This is to certify that Maine Medical Center/William Berry & Sons, Inc. has permission to Demolition & construct new parking garage for bridge overpass at 2 Bramhall St AT 053 D007001

Permit No: 04-1451	Issue Date: MAY 26 2006	CBL: 053 D007001
-----------------------	----------------------------	---------------------

Job Name: MAINE MEDICAL CENTER - GARAGE/HELIPAD/LOBBY CORRIDORS

From: Mike Nugent [MJN@portlandmaine.gov]
Sent: Thursday, May 18, 2006 1:01 PM
To: Silbert, Bailey
Cc: Swallom, Brad; Davis, Keith
Subject: Couple of final questions/Garage segment

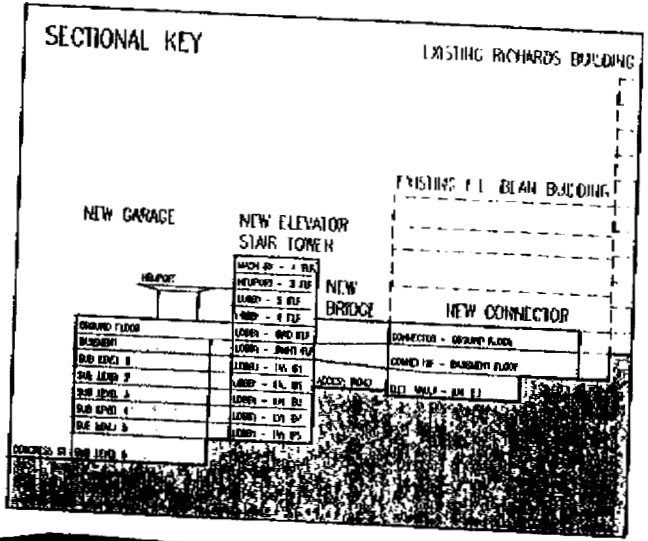
Please provide a statement of compliance with rational far Section 1007. Accessible Means of Egress.

Are the Exit stairways "Smoke proof Enclosures" in compliance with Section 1015?

The exterior stairway from the helipad, is there a ward on the helipad level so people can't fall into the stairway?

SEE ATTACHED ABSTRACT FROM
STRUCTURAL DRAWINGS
SHEET S001 PKG. E
